Code for Adoption Agreements

Sewerage sector documents: Change proposal (Ref 013)

Modification proposal	Sewerage Sector Guidance Appendix C – Design and Construction Guidance: Position of a reducing slab over a cover slab
Independent Sewerage Adoption Panel Recommendation	The Panel recommended making a change, but proposed using an alternative approach
Decision	Ofwat has approved making a change using the alternative approach recommended by the Panel.
Publication date	16 March 2023
Implementation date	01 April 2023

Figure 1 – diagrams of reducing slabs over a sewer cover slab

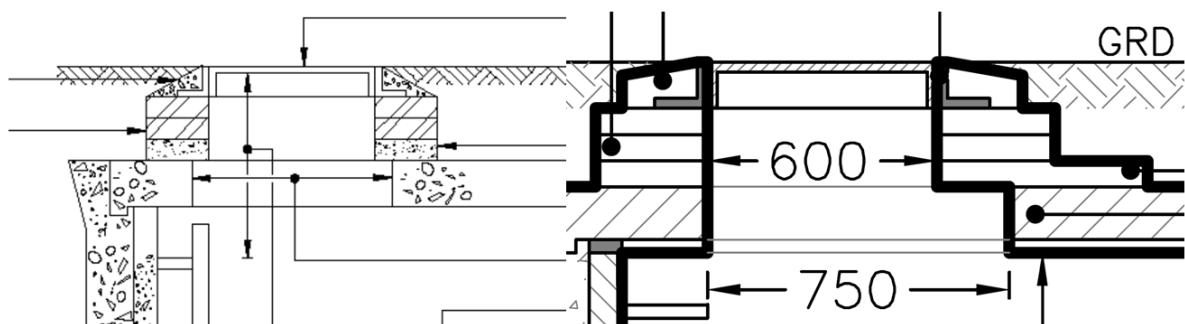
In its change proposal, Vistry stated that the diagrams used in section B5 of the DCG for the design of sewer maintenance holes are incorrect. Vistry considers the sewer cover slab should be eccentric rather than symmetrical. It stated that the current diagram "...should not have that lip/overhang, it simply needs to be square and the eccentric larger opening spans the rear 150mm." It provided an example diagram (figure 1) of a reducing slab over a cover slab. It considers that the design on the left, which is taken from the DCG is incorrect and provides an example of a correctly designed diagram on the right.

In reaching its decision, the Panel stated that it considered that the proposal appears to have conflated diagrams for maintenance holes with ladders with those with step rungs. In particular, the response from the Water UK Standards Board clarified this point:

“Step rungs nominally project 125mm from the face of the manhole chamber but ladders nominally project 200mm. To accommodate these different offset distances the corbel slab is placed in different positions. It would be flush with the edge as drawn by your correspondent if there are step rungs in the chamber, but it would be offset by 75mm as shown in the Sewerage Sector Guidance in the case of a ladder.”

Accordingly, the Panel was not satisfied that the figures in the DCG should be amended as proposed, as this would create errors depending on the type of maintenance hole being used.

“The stand-off distance from the wall of the manhole to the rungs of a ladder is typically greater than the stand-off for double step rungs. To align the opening correctly using standard components, a cover slab with a larger opening should be used together a corbel slab to avoid the ladder obstructing the clear opening.”

“Corbel slab to E.30.2 aligned so that the ladder does not reduce the clear opening of the cover (see B5.2.28)”
